**Commonwealth Edison**

September 18, 1981

Subject: Byron Station Units 1 and 2  
Braidwood Station Units 1 and 2  
Responses to FSAR Questions  
NRC Docket Nos. 50-454, 50-455,  
50-456 and 50-457

ATTACHMENT A

FIGURE 3.3-49  
 CONTAINMENT BUILDING  
 PRIMARY SHIELD WALL  
 AT OUTLET NOZZLE

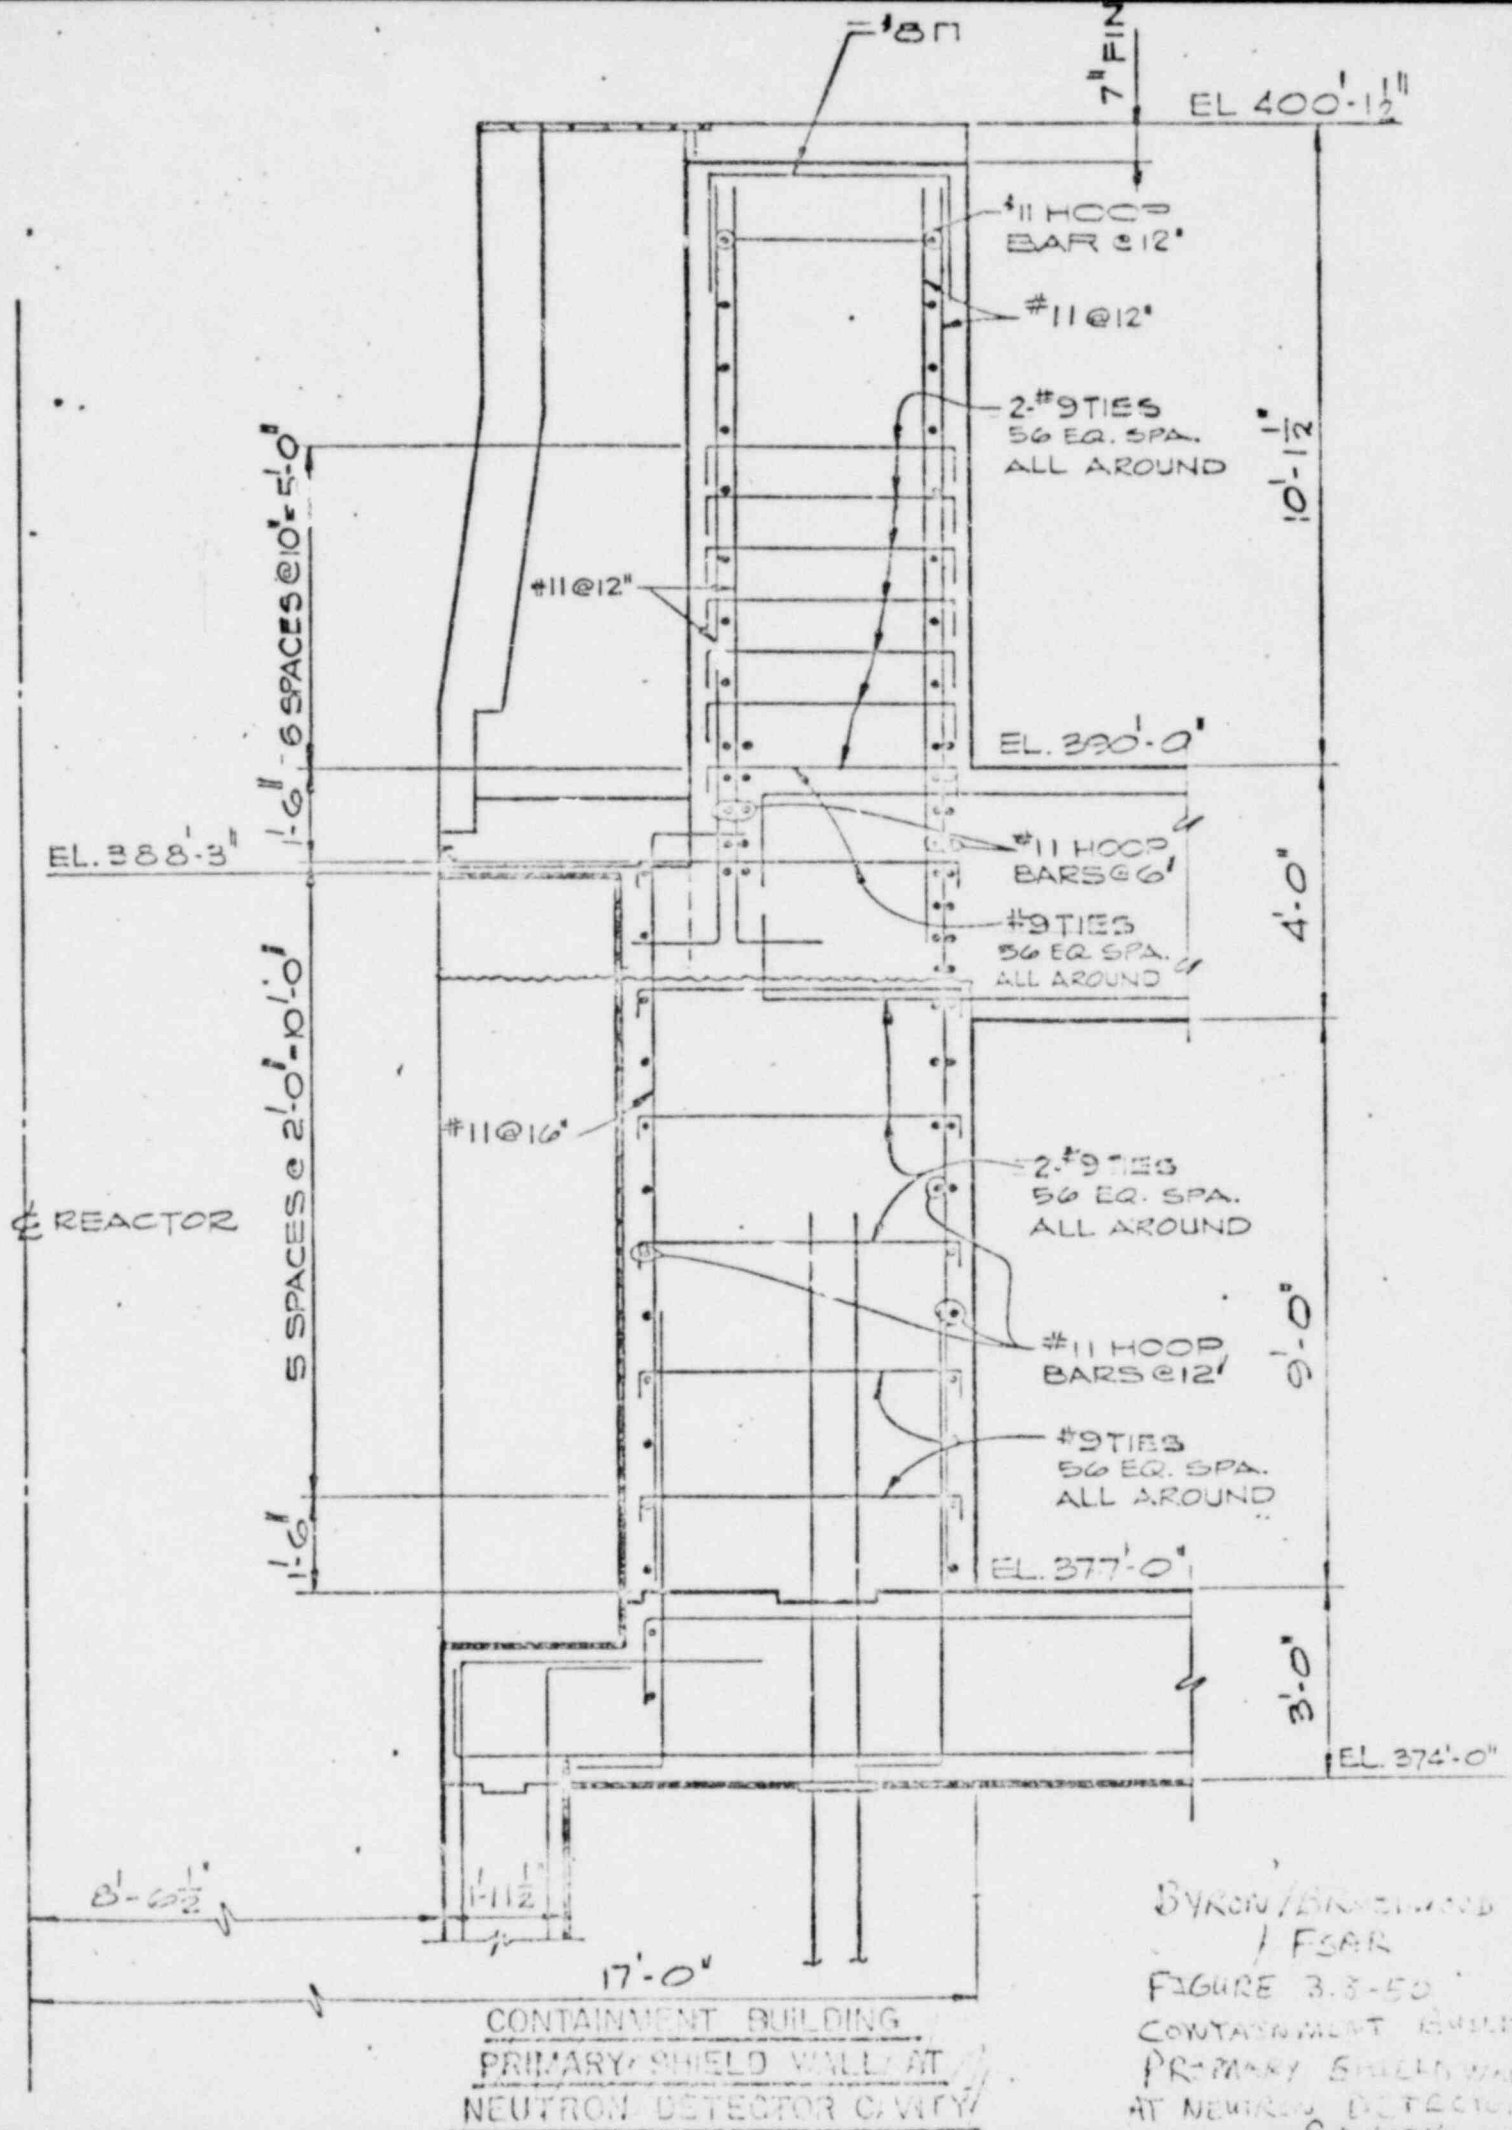
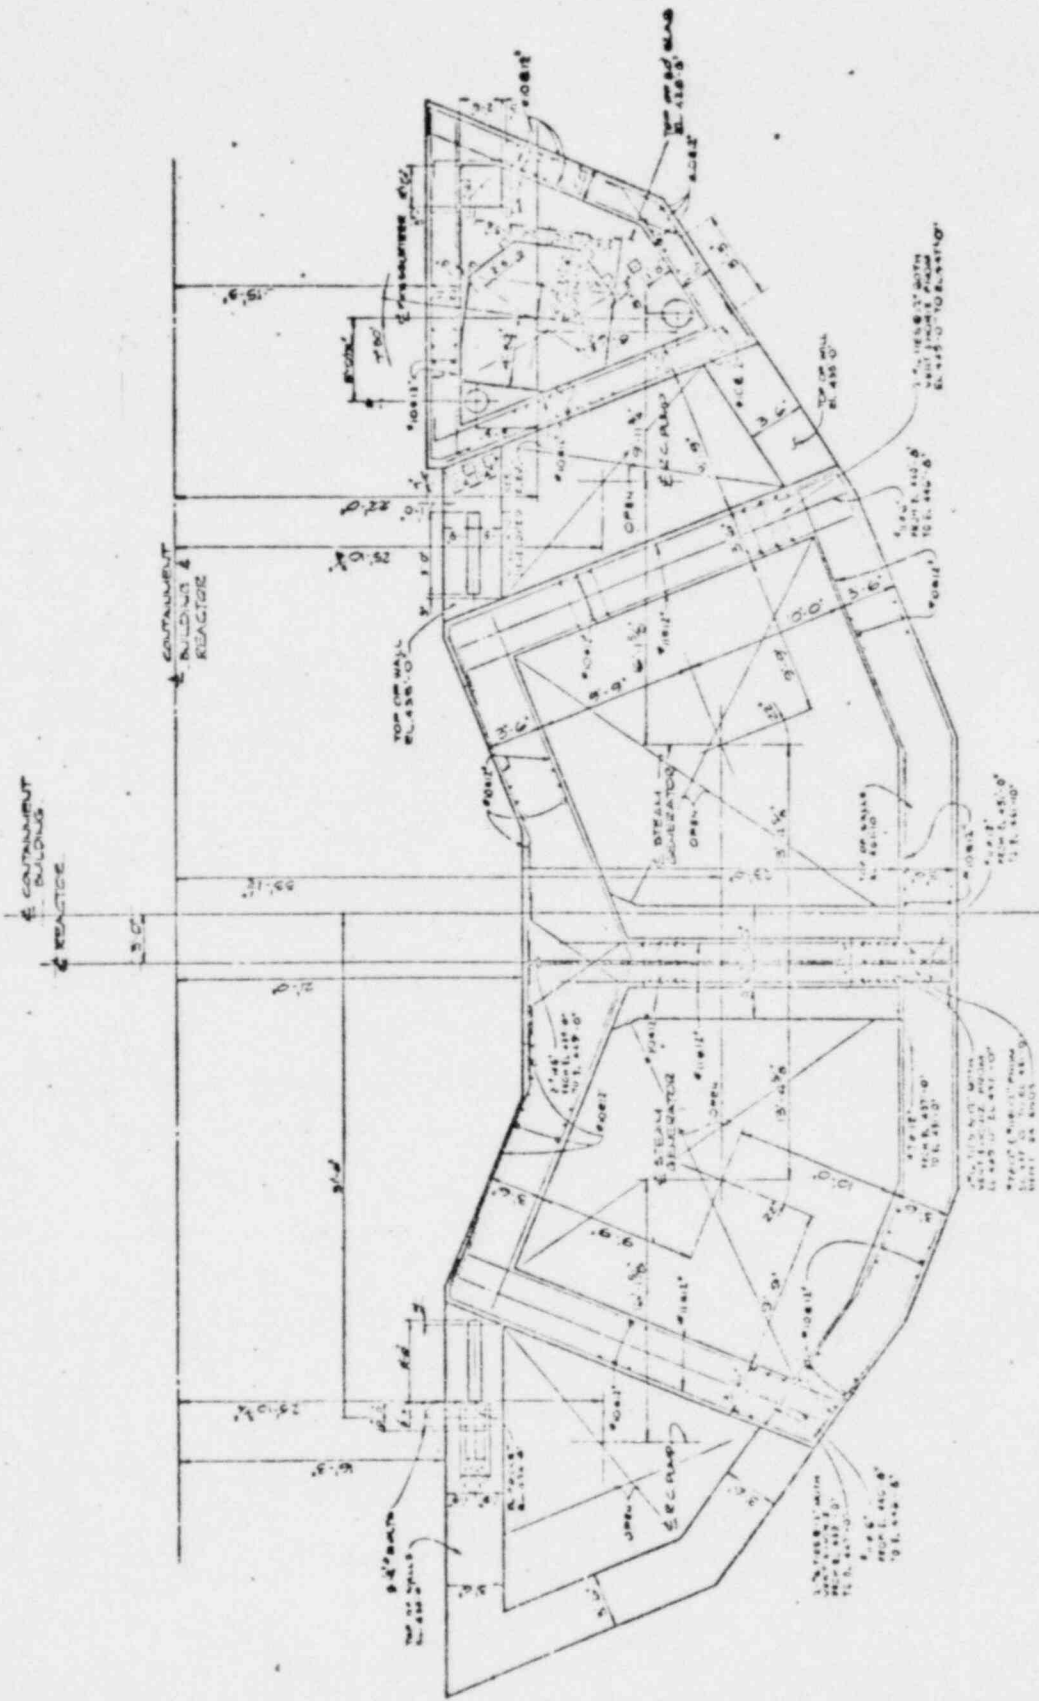
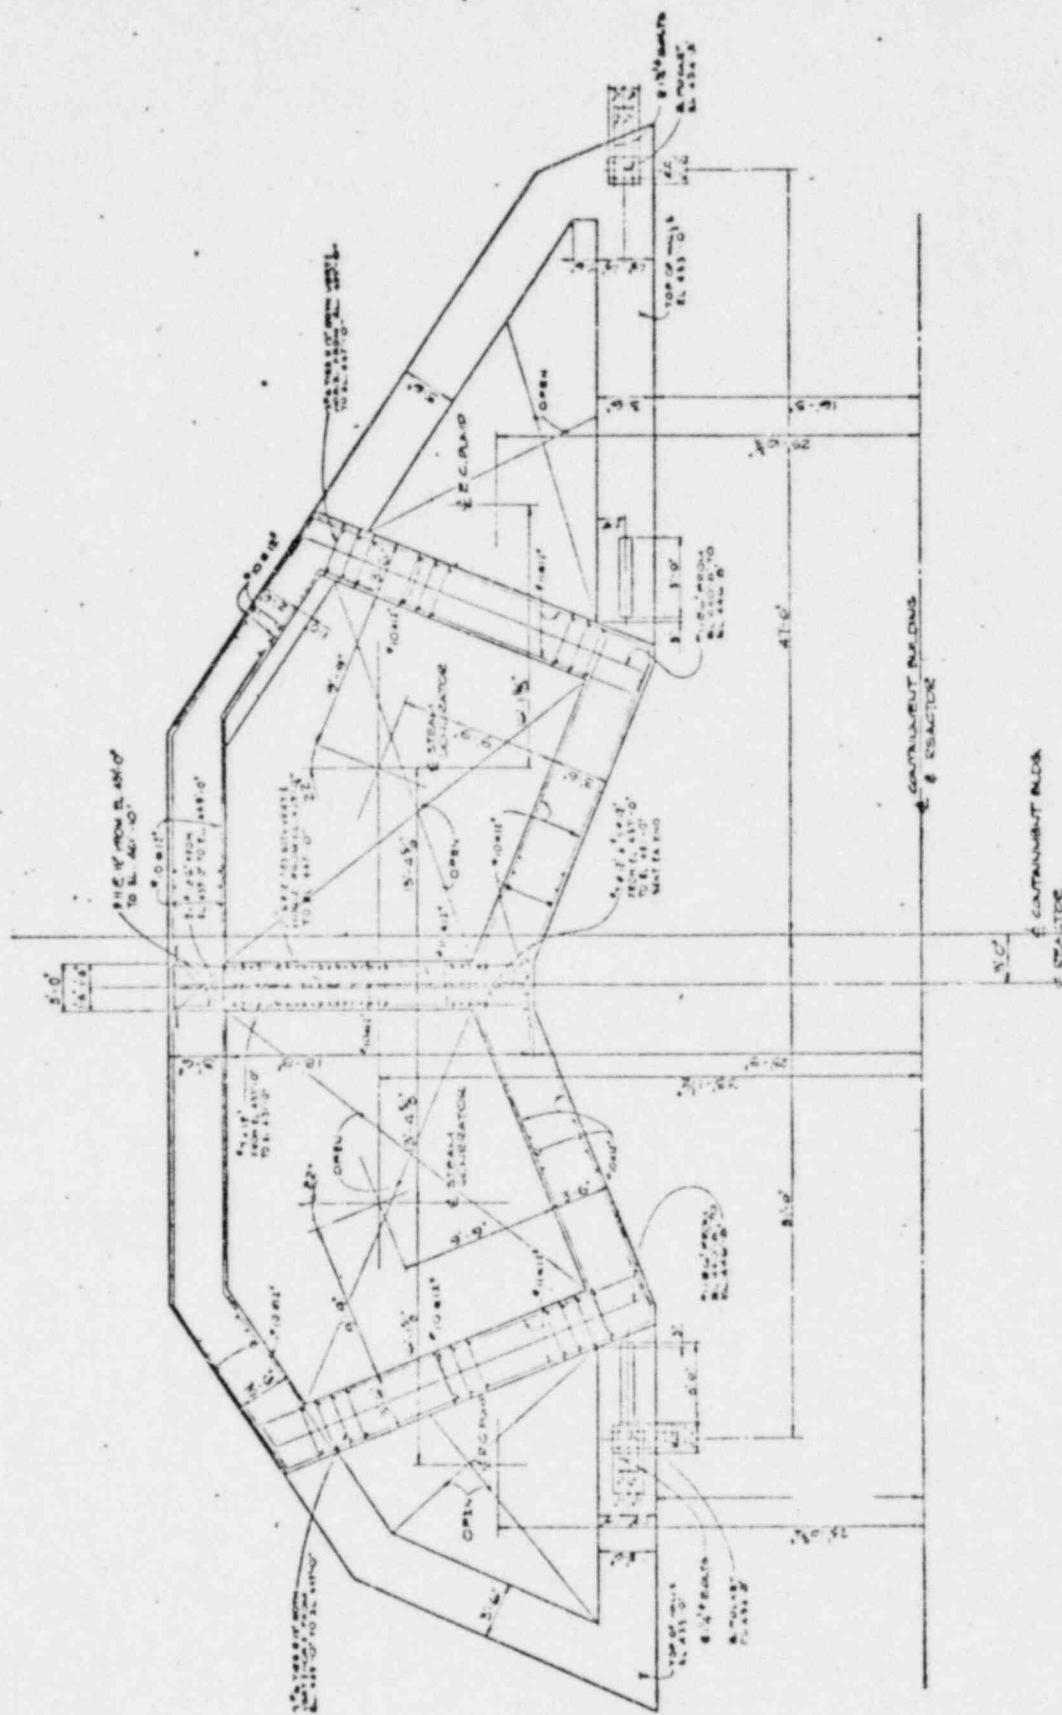
Containment building sections in the east-west and north-south directions, primary shield wall, and NSSS component enclosure plans are shown in new Figures 3.8-46 through 3.8-51. These figures, together with the descriptive information in Subsections 3.8.3.1.5 through 3.8.3.1.8 and Figures 3.9-4 through 3.9-9, define sufficient detail for a structural review of the containment internal structures.
